TALLAWONG STATION **PRECINCT SOUTH**

ADDENDUM URBAN DESIGN REPORT

Rev. F_20.01.2021

AMENDMENTS TO BUILDING ENVELOPES FOOTPRINT & STOREYS

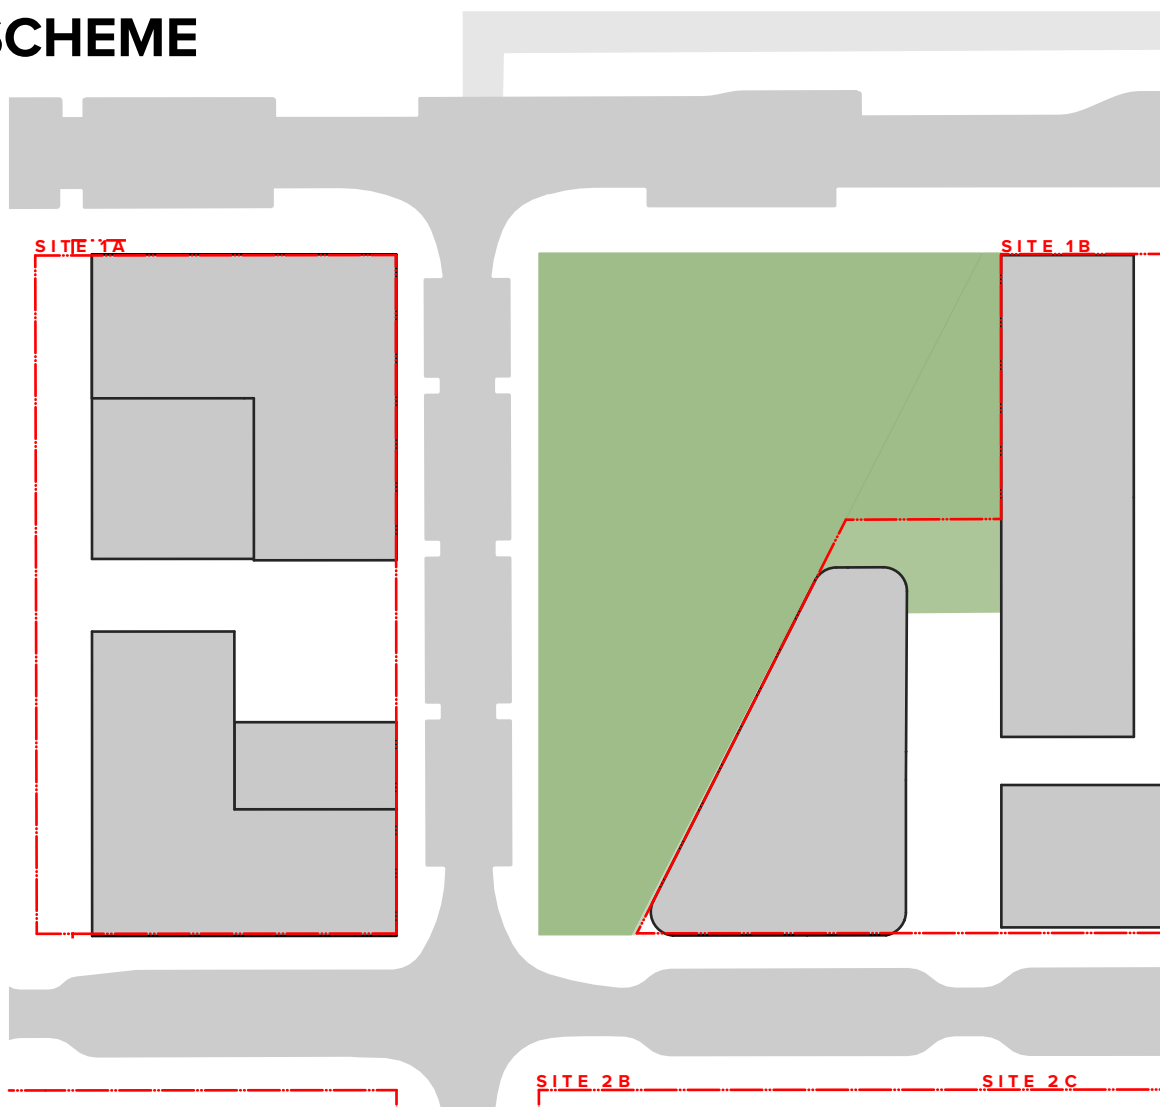
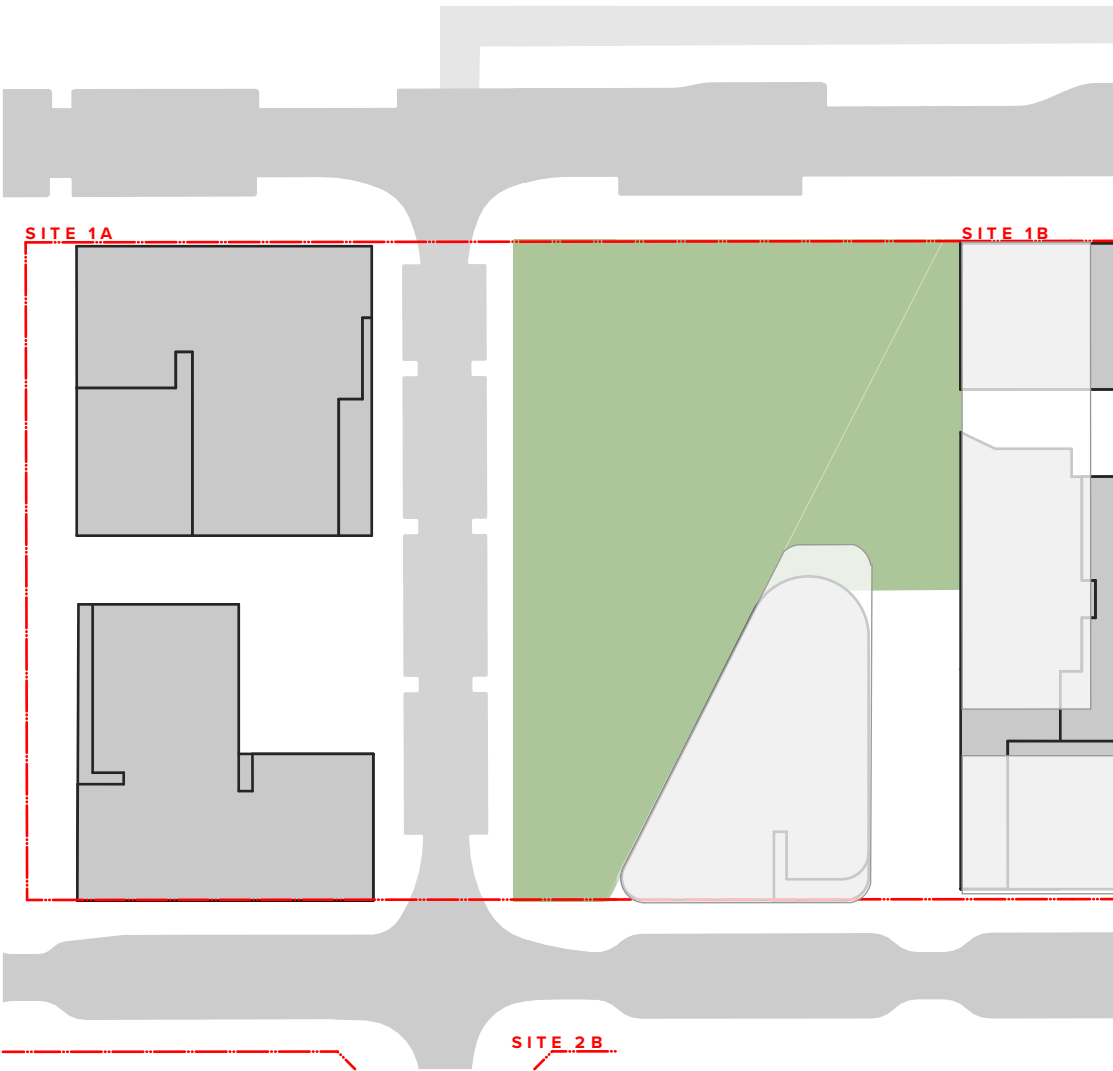
- ✓ Locally shift the built form to maximise solar access to the plaza and building facade
- ✓ Step the built form down to the park and commuter carpark to create a retail podium and provide opportunities for extended outdoor areas above

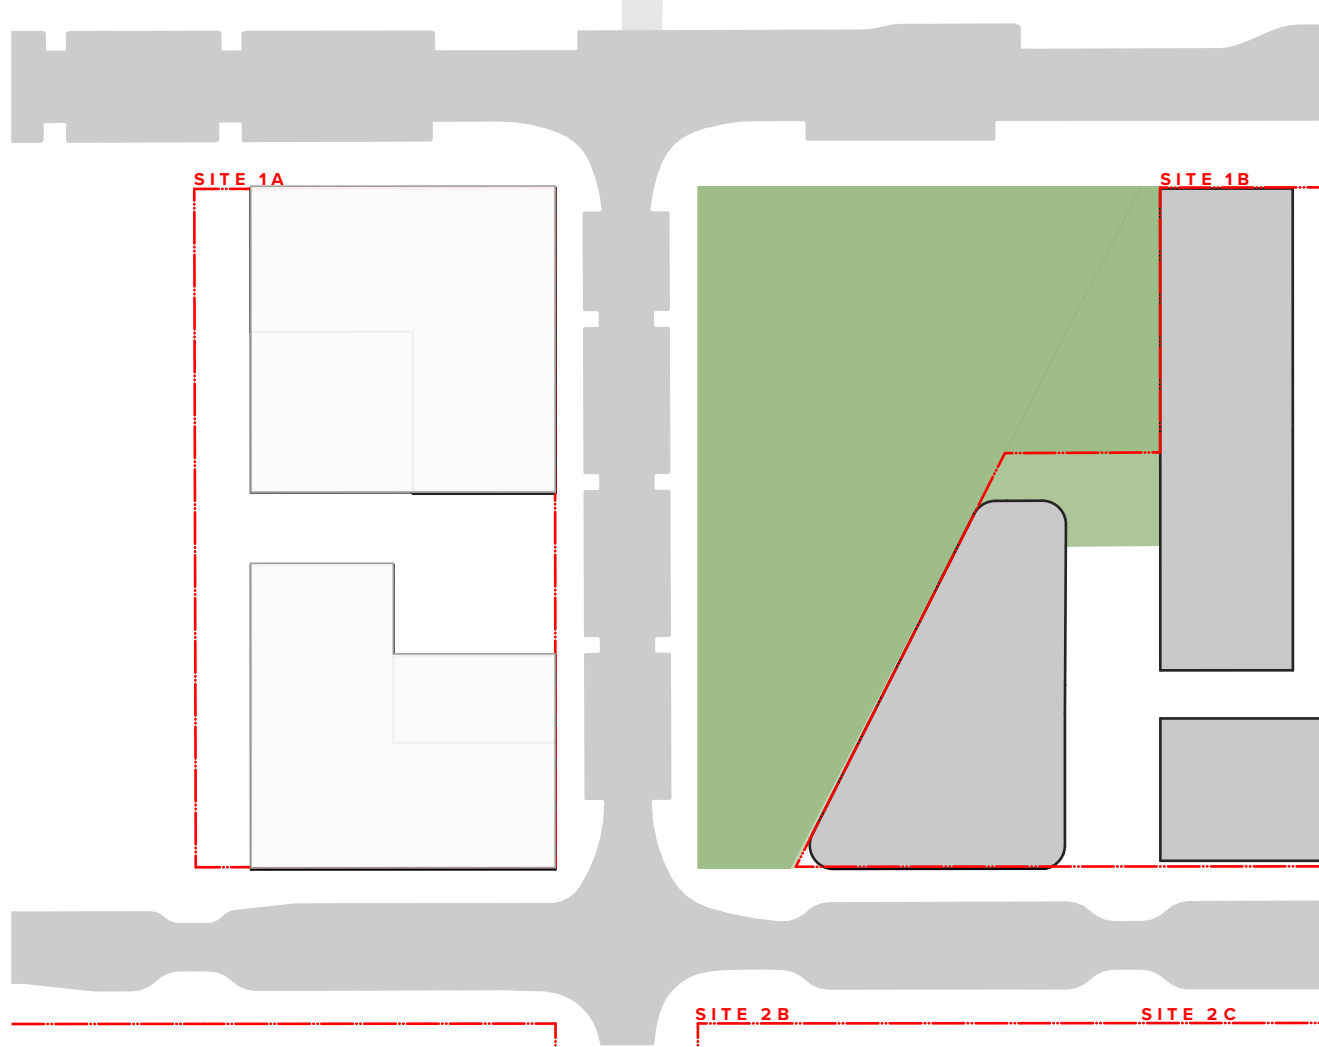
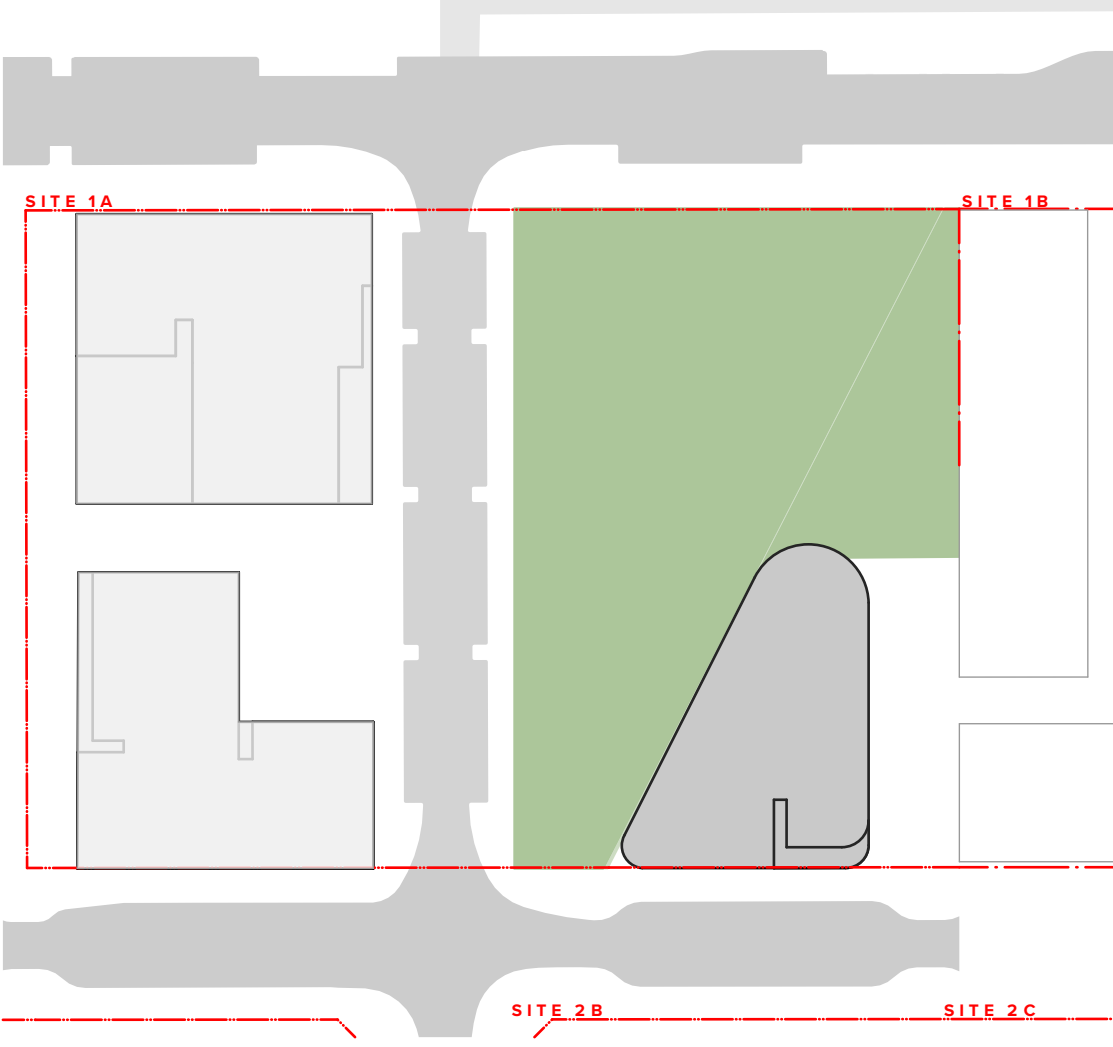
- ✓ Reduce building footprint to object building to provide a direct visual and physical connection to the pedestrian boulevard from commuter carpark, increasing the size of the public park

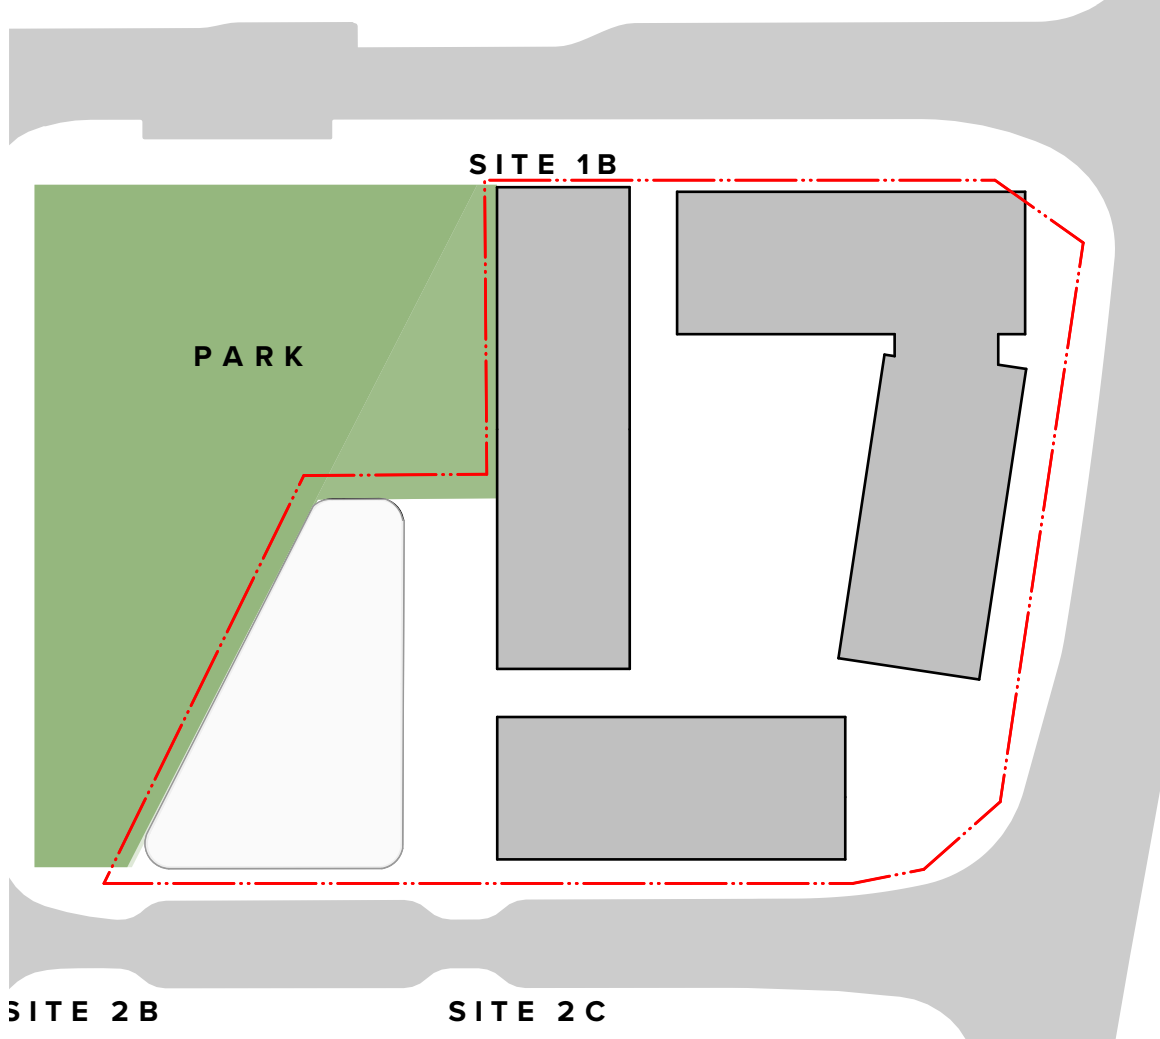
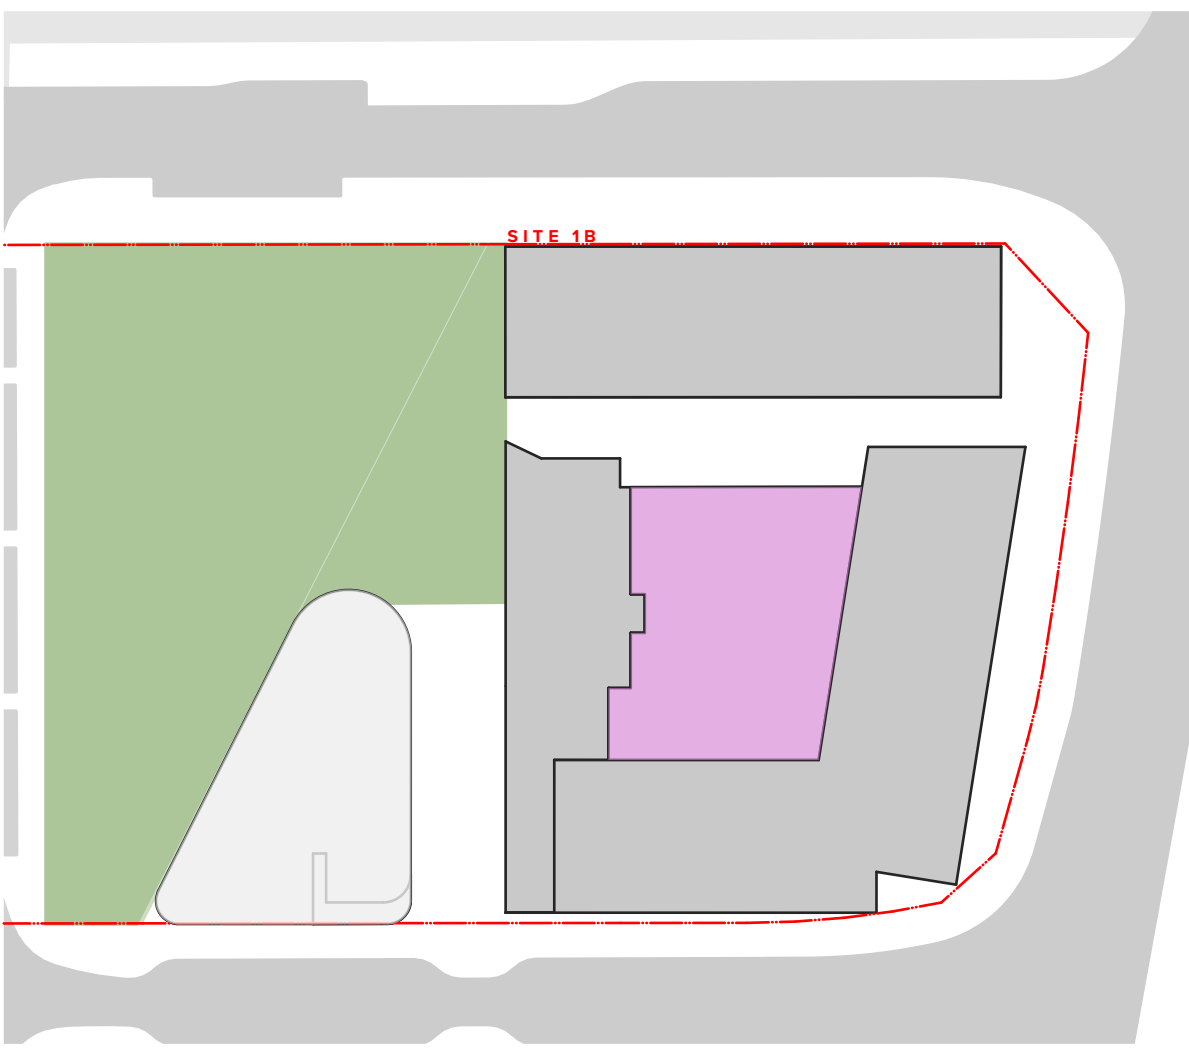
- ✓ Shift building forms to respond to new through site link
- ✓ Reconfigure the built form to define the corner of Cudgegong Road and Conferta Avenue, creating a gateway to the residential precinct

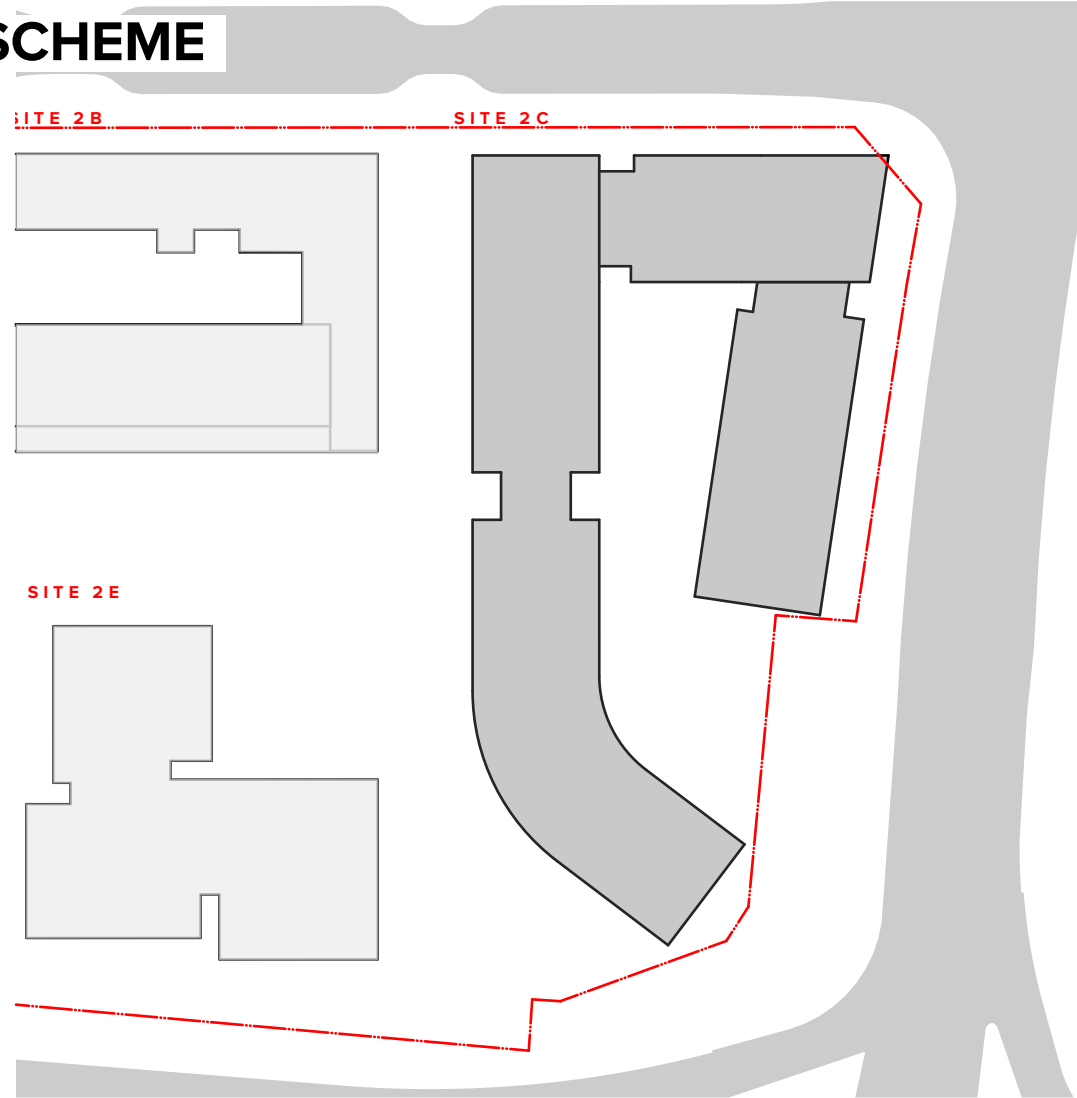
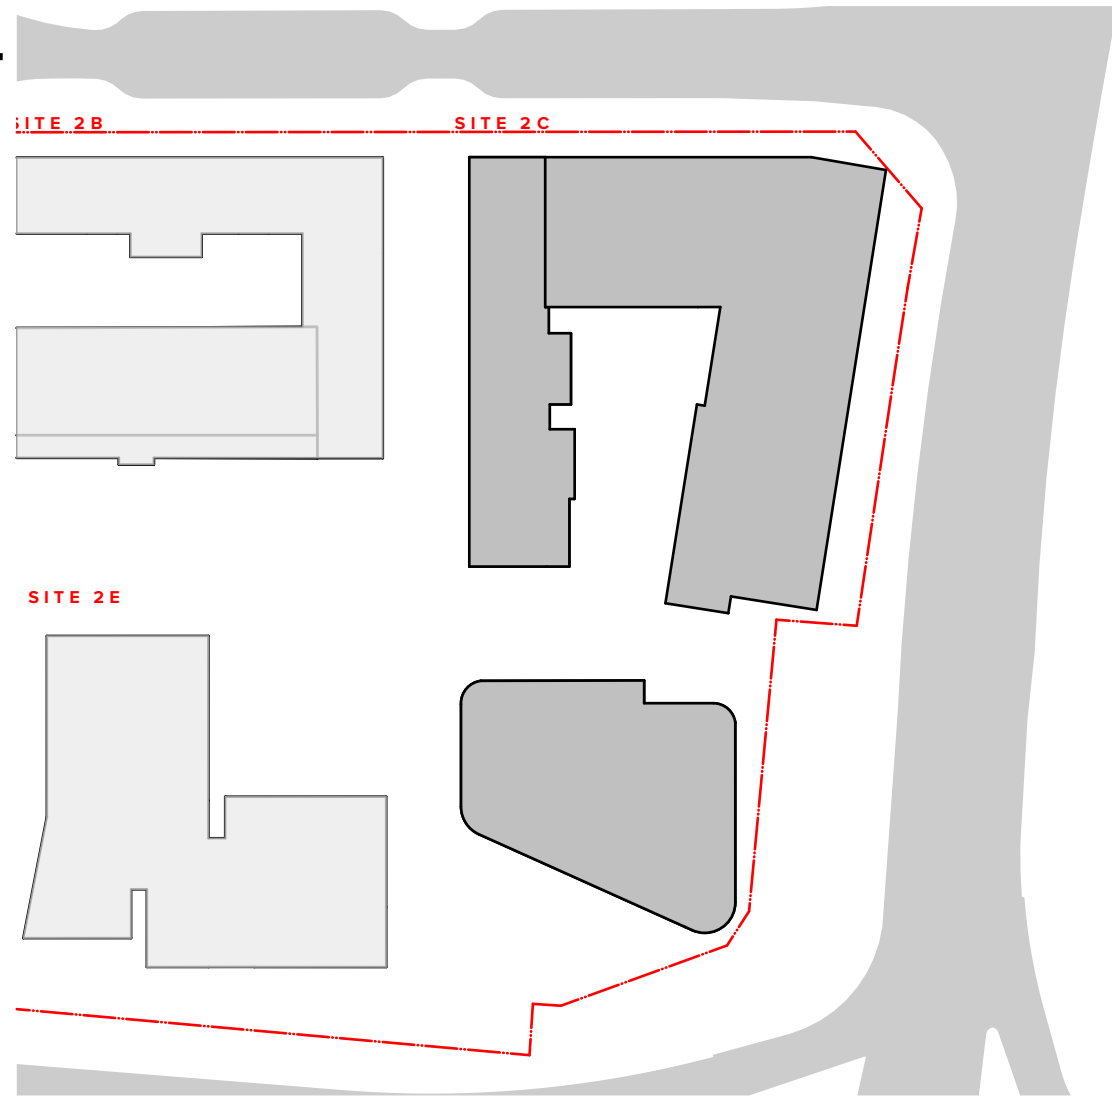
- ✓ Redistribute built form to maximise solar access to shareway/plaza
- ✓ Reduce building lengths to increase visual and physical permeability through the site
- ✓ Redistribute heights to provide a lower scale building interface along the length of the pedestrian boulevard
